April 8, 2022

Re: Protected Bikeways Adjacent to Vancouver Parks

Figure 1 - Ogden Ave in Kits Point

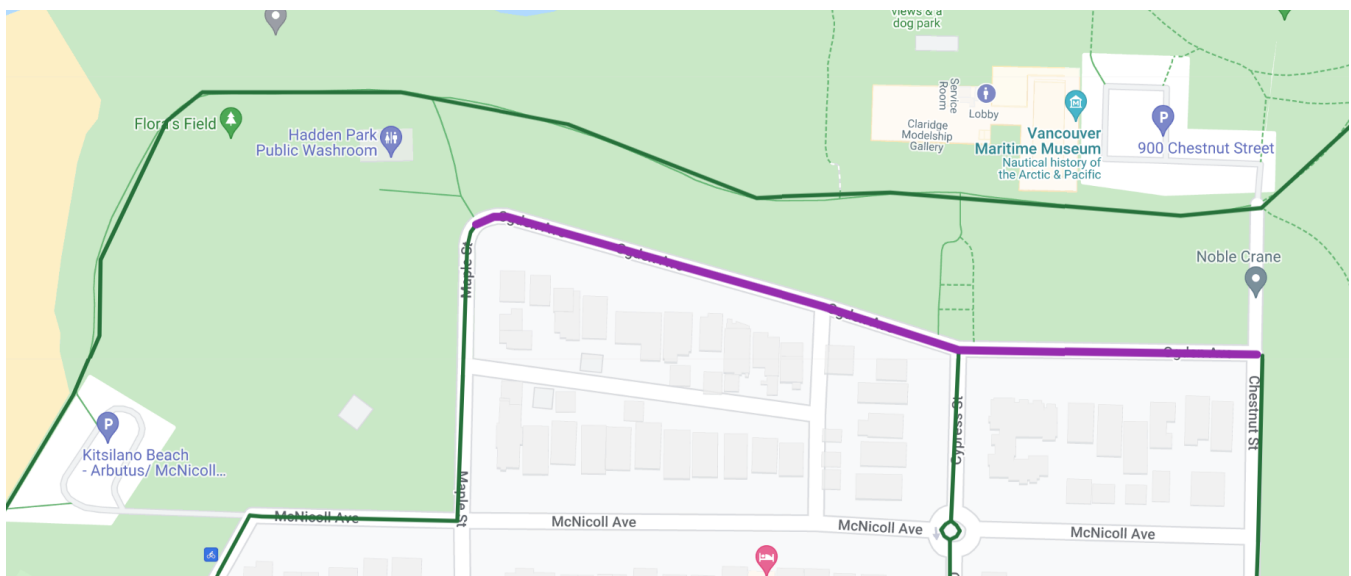
Ogden Ave is a key link along the Seaside Greenway, and runs along the south edge of Hadden Park. The gap is shown in purple in Figure 1, below. There is a gravel multi-use path within Hadden Park, that is often at or over capacity, but there are no immediate plans to improve it. The map shows both the official off street Seaside Greenway, and the on street Seaside Bypass, in green.

From Maple St to Chestnut St, there is currently no stopping permitted on the north side of Ogden Ave. The built roadway appears to be sufficiently wide, and this width in fact can lead to some vehicle operators speeding. A curb protected bidirectional lane in this location would resolve conflicts on the current narrow path at the top of the embankment, and direct people from Vanier Park towards the new improved Seaside Greenway route. This looks to be a straightforward improvement that could be made immediately, with little to no impact on vehicle traffic.

Figure 2 - Victoria Dr and E 19th St gap in the cycling network

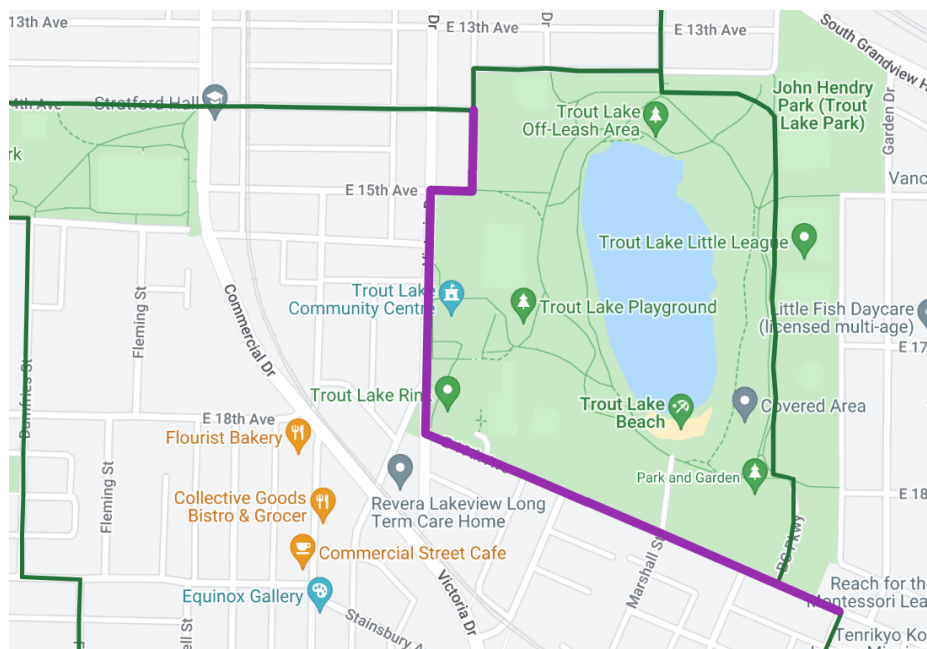
This route, shown in purple in Figure 2, provides a critical connection from the 14th Ave bikeway to the BC Parkway, and also to the Trout Lake Community Centre, an important local destination.

The current plans to renew John Hendry Park do not adequately manage transportation cycling in this area, with the proposed shift of the BC Parkway east and north. From the public engagement sessions held by the Park Board, a proposed MUP generally along this route is intended to be gravel, and not appropriate for transportation cycling nor for allowing people who are cycling easy access to the primary park destination, the community centre. Figure 3 shows the proposed relocation of the BC Parkway in red, and the proposed gravel MUP connecting 14th to the BC Parkway in yellow. Other changes proposed to this area include a new Community Plaza at the Community Centre, with no access for those choosing to travel by bike, and the relocation of the Farmer's Market to the south end of the park, with likely congestion around the south parking lot and proposed MUP.

There is very limited parking currently permitted along these streets. Planned improvements to Stainsbury are a welcome addition to the cycling network, but will not provide access to the Trout Lake Community Centre. These improvements along Victoria Dr and 19th Ave could be actioned now, without waiting for the implementation of the John Hendry Park Renewal Plan.
